## ADDENDUM TO THE CONTRACT

### AURORA HARBOR REBUILD, PHASE III Contract No. DH23-015

**ADDENDUM NO.:** ONE

**March 6, 2023**

**F28**

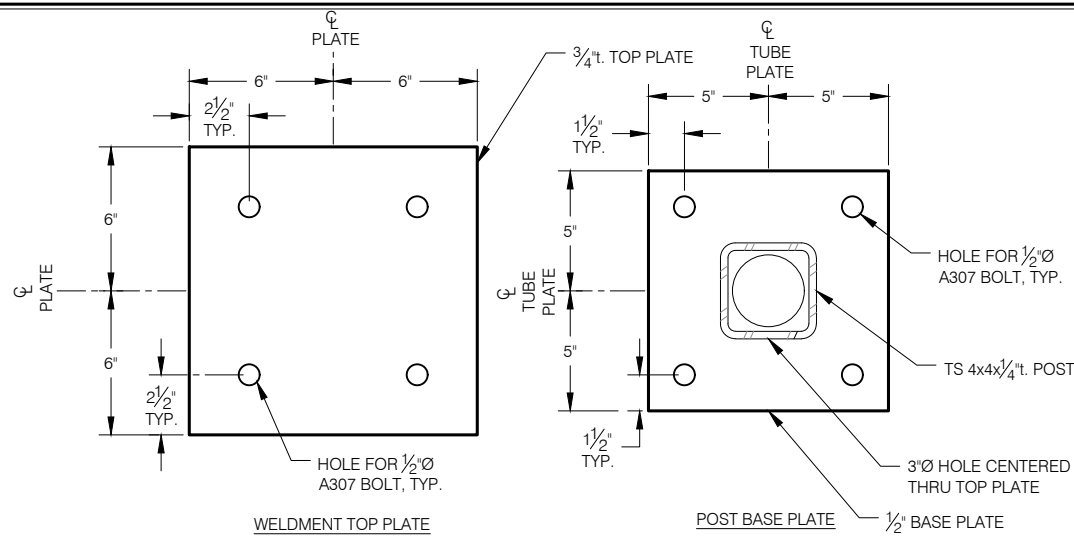
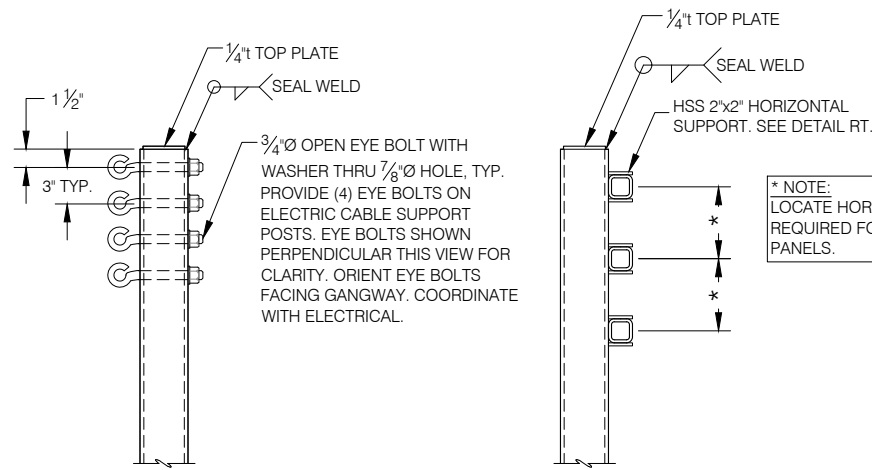
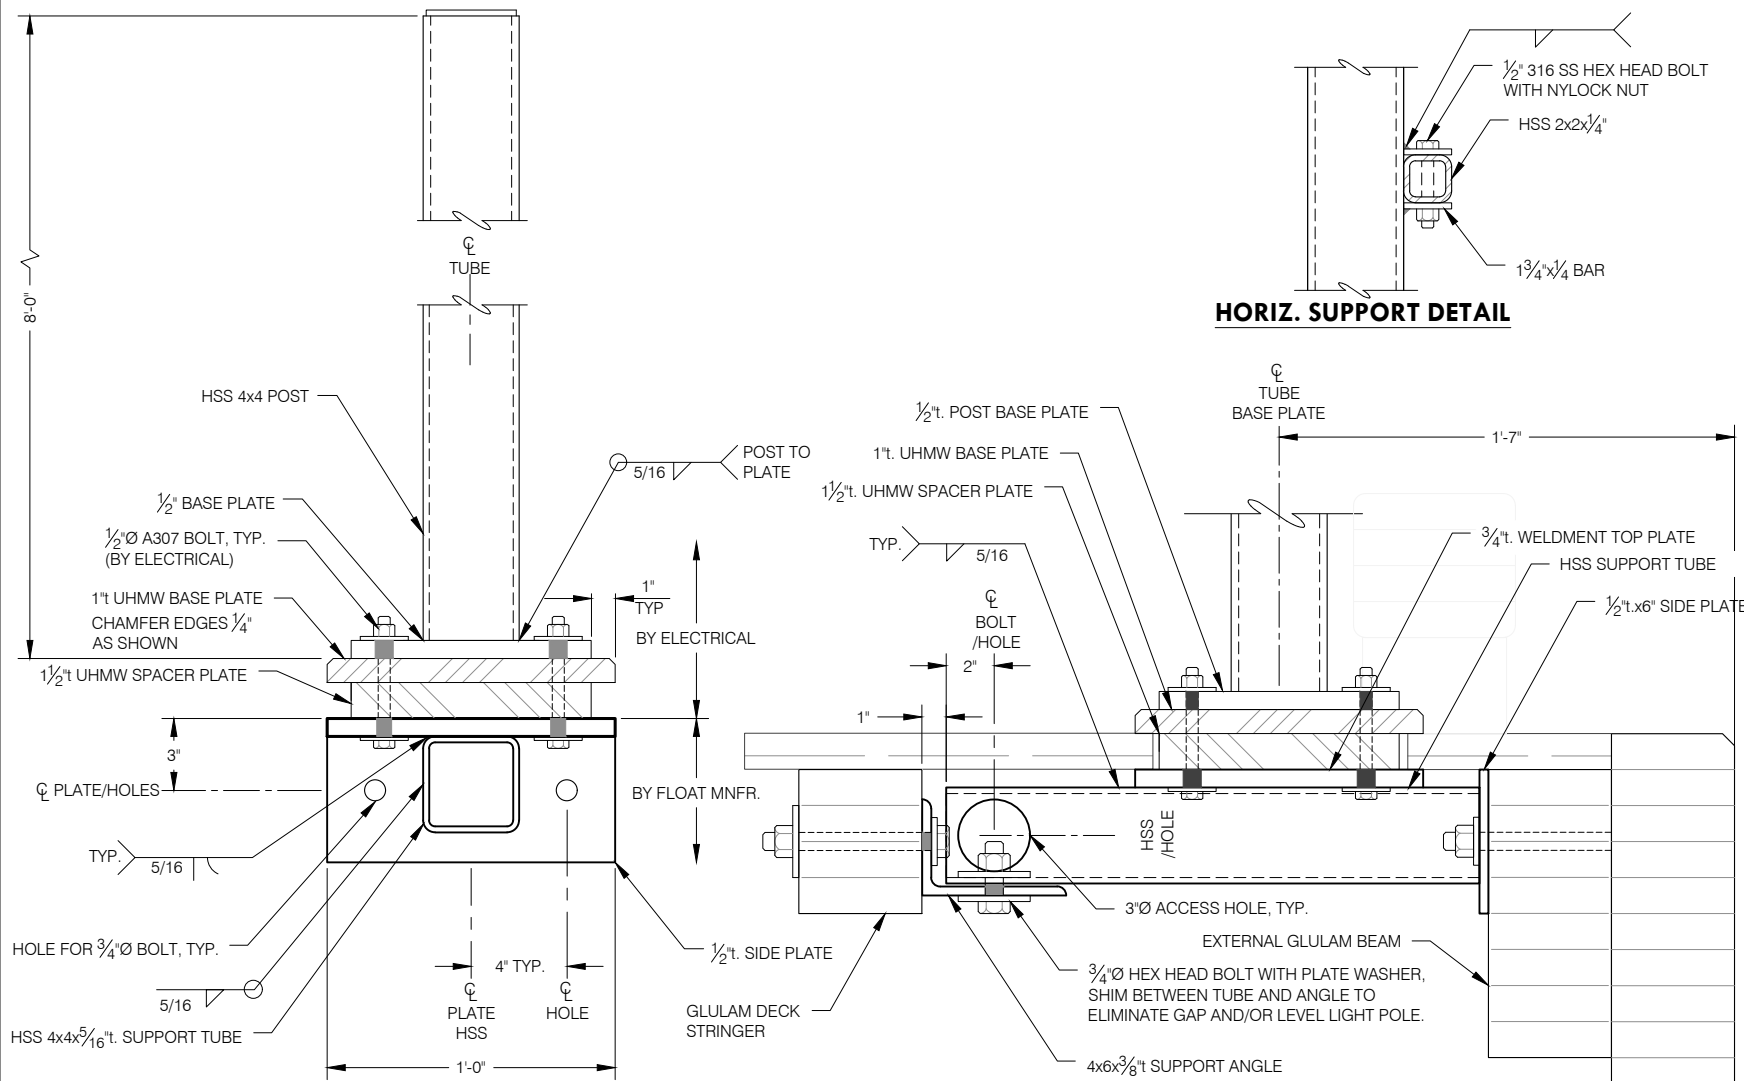
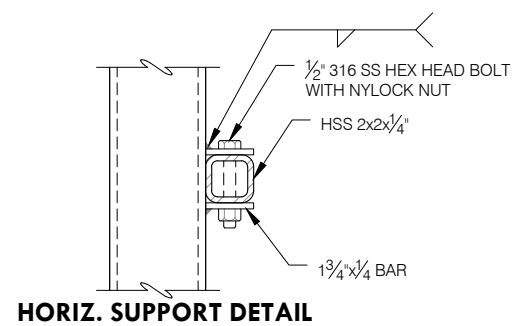
Question: *“Sheet R2- Clarify electrical support posts”*

Response: The electrical support post BASES are existing in the float, and will be re-used. The electrical support POSTS shall be furnished new by the contractor.

**E6**

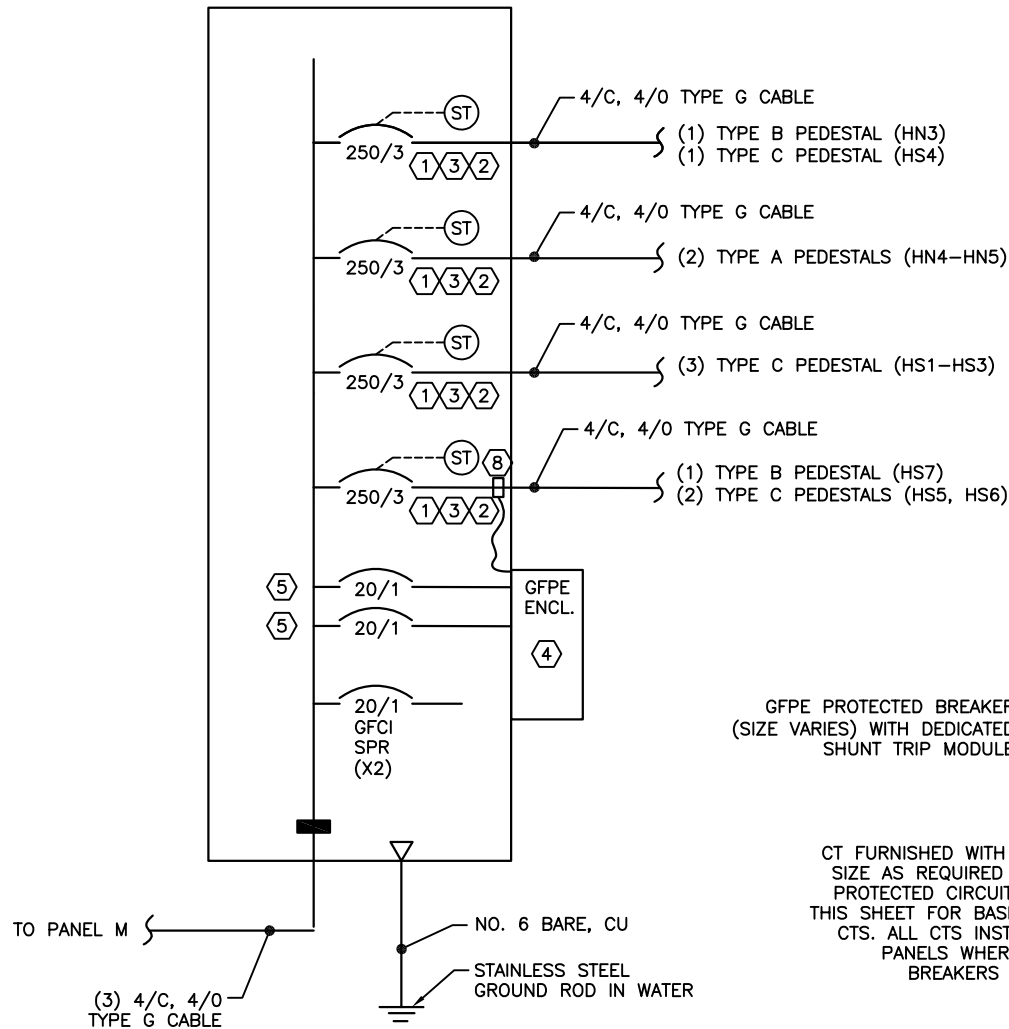
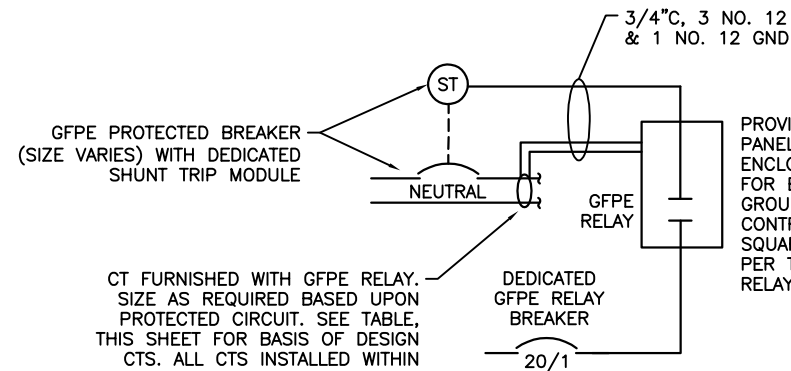
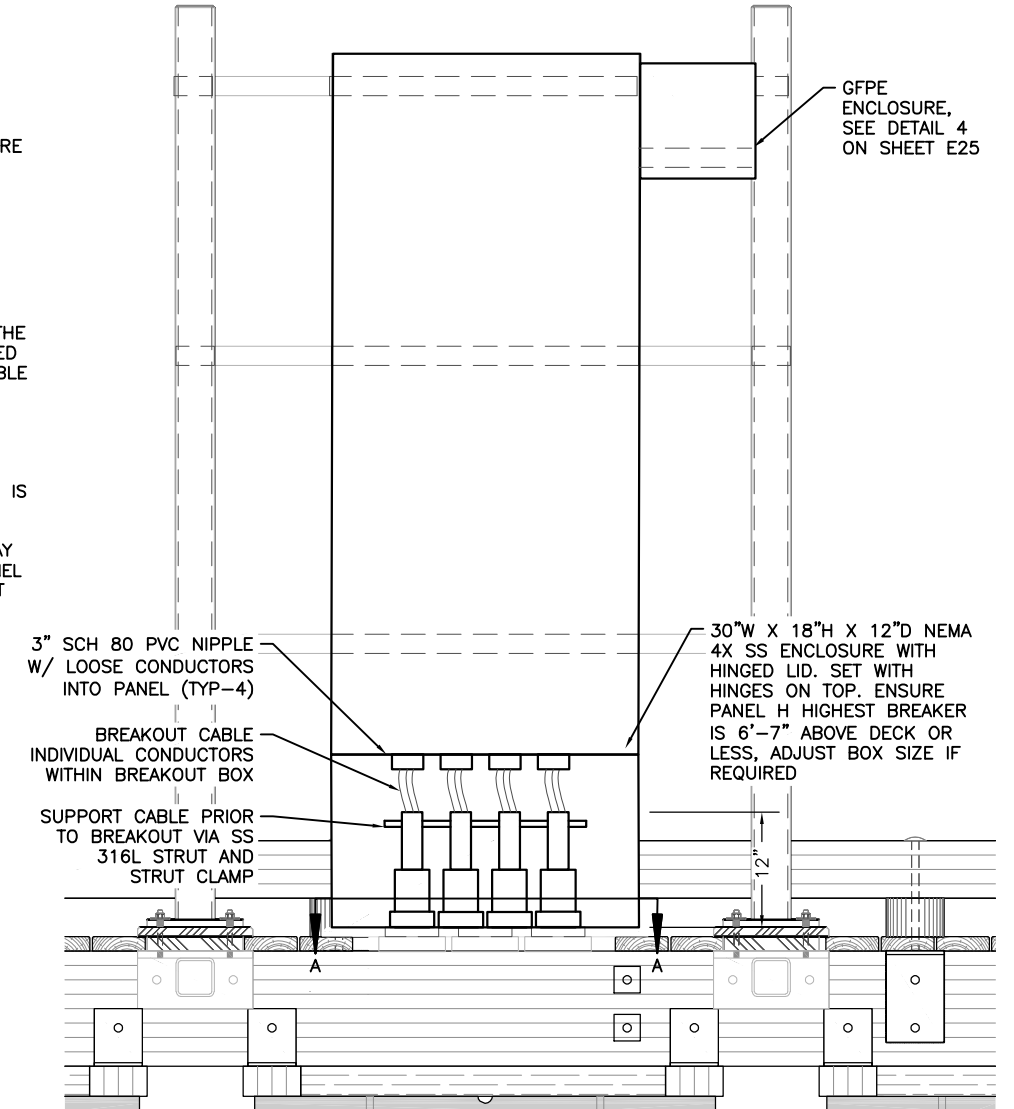
- Item No. 20 SHEET E6, SINGLE LINE DIAGRAM- PANEL H & GFPE BREAKER DETAIL, **Replace** existing sheet with attached SHEET E6 labeled Addendum 1.

**E10**

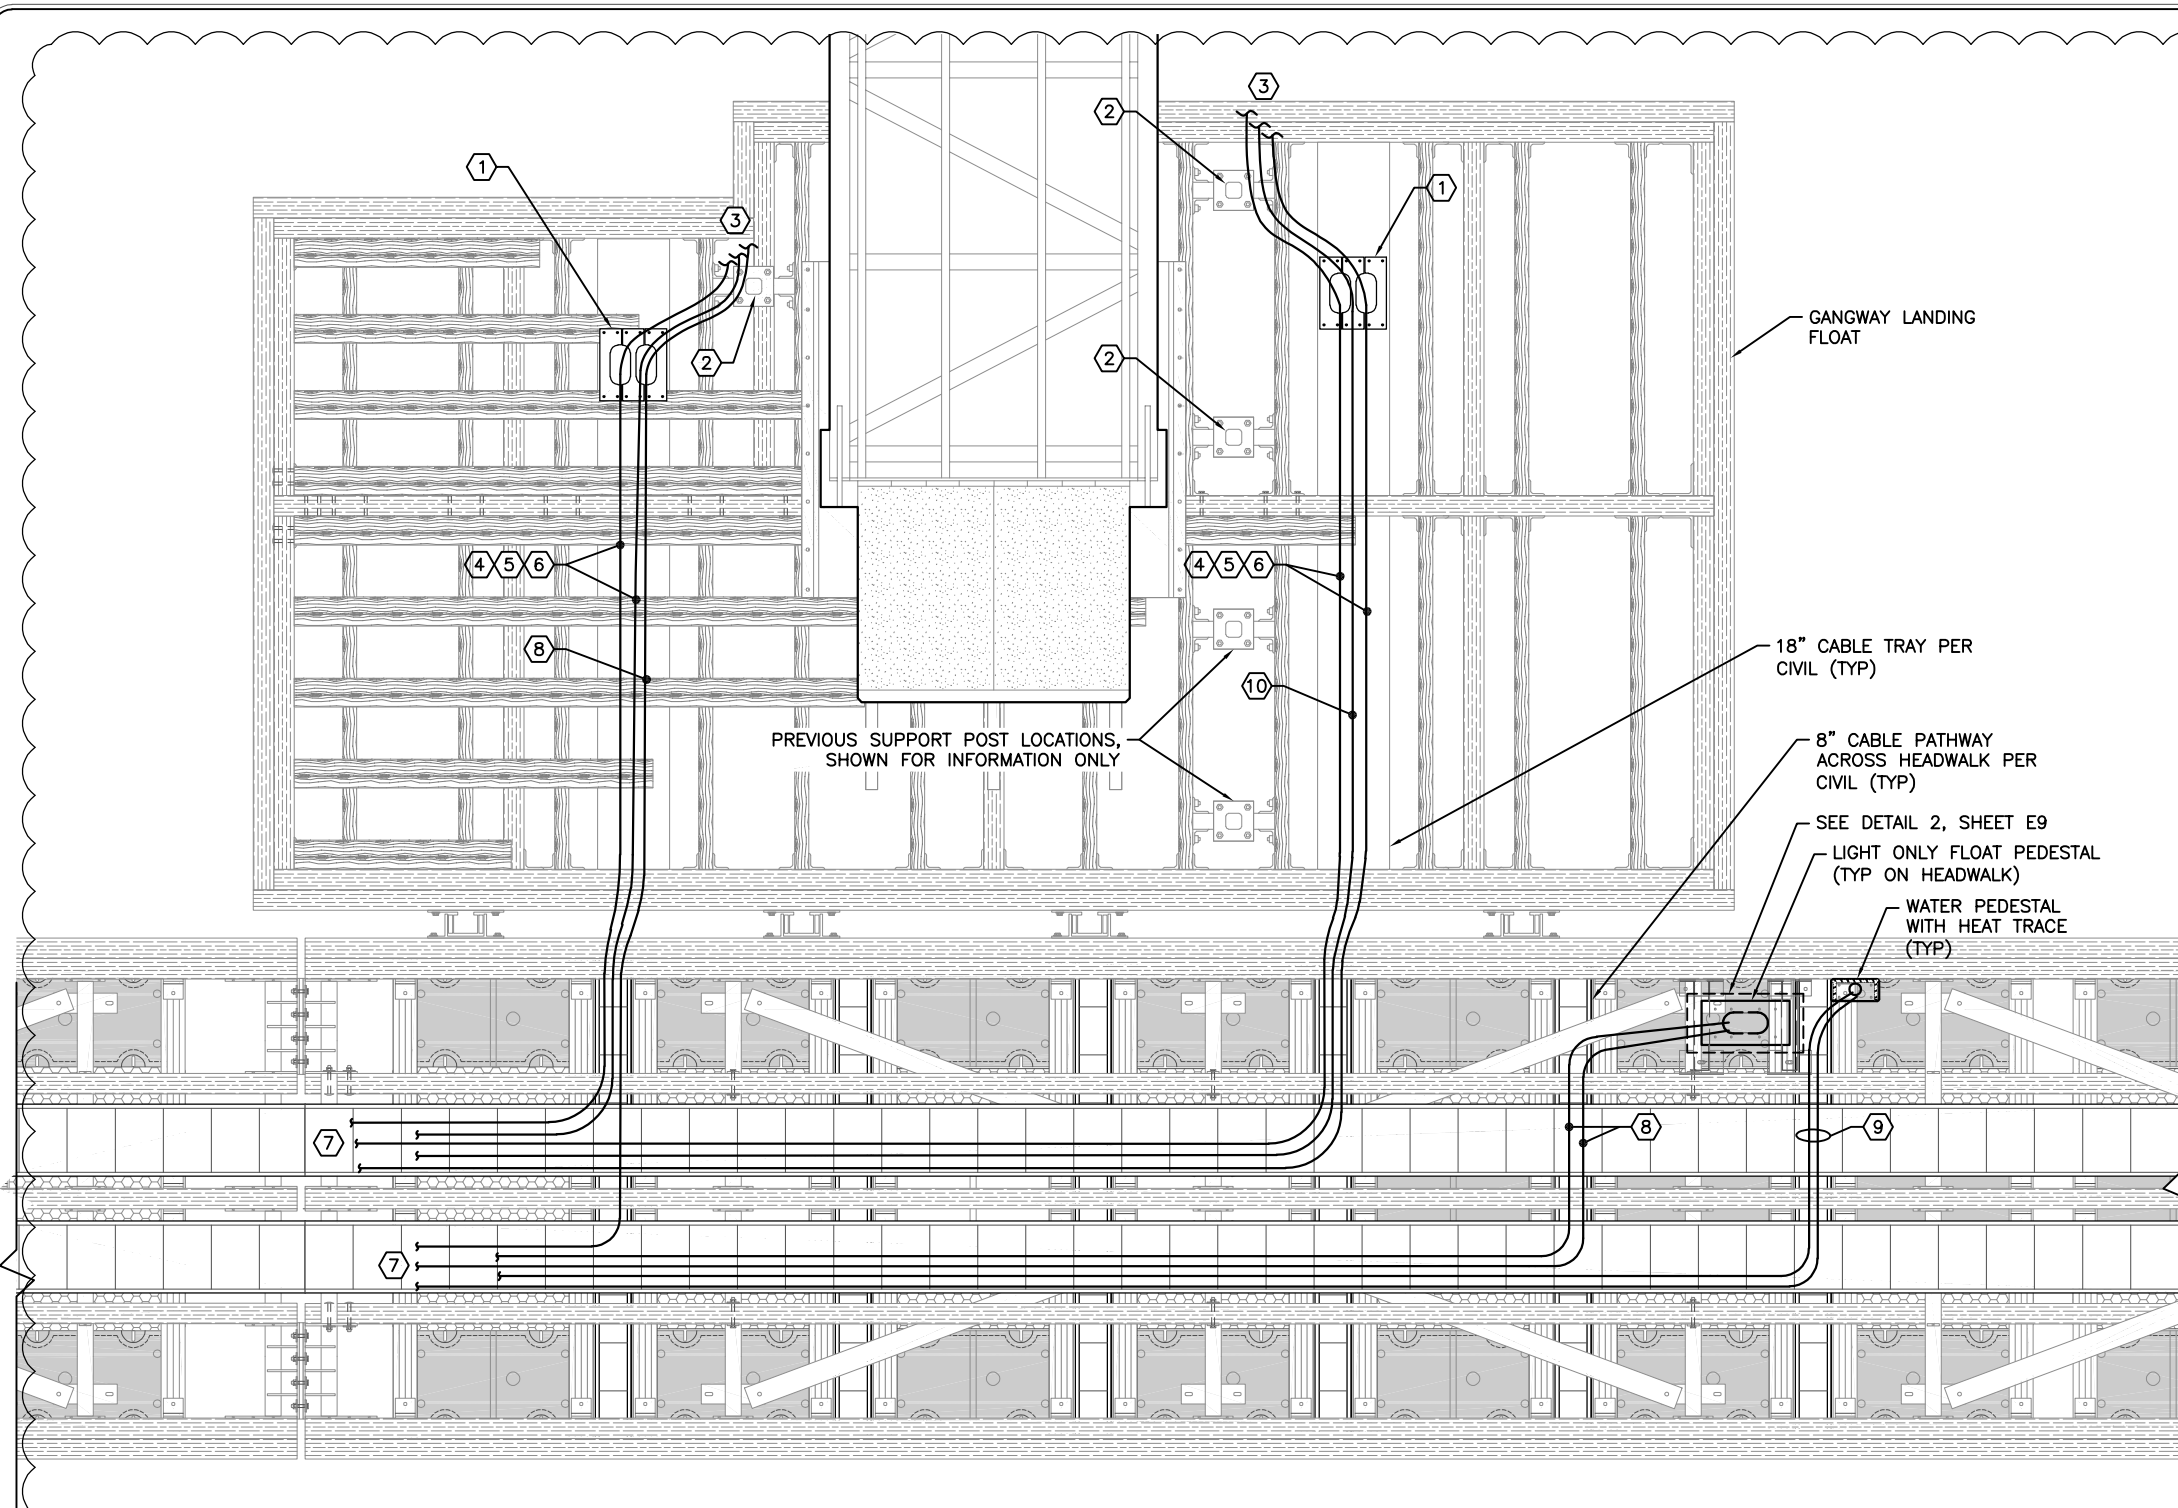
Item No. 29 SHEET E10, GANGWAY LANDING FLOAT AND HEADWALK PLAN, **Replace** existing sheet with attached SHEET E10 labeled Addendum 1.

- 12. CONTRACTOR RESPONSIBLE FOR PROVIDING AND COORDINATING STRUCTURAL ELEMENTS ASSOCIATED WITH FLOAT MOUNTED ELECTRICAL. SEE GENERAL NOTE 32 ON SHEET E1 FOR MORE INFORMATION.
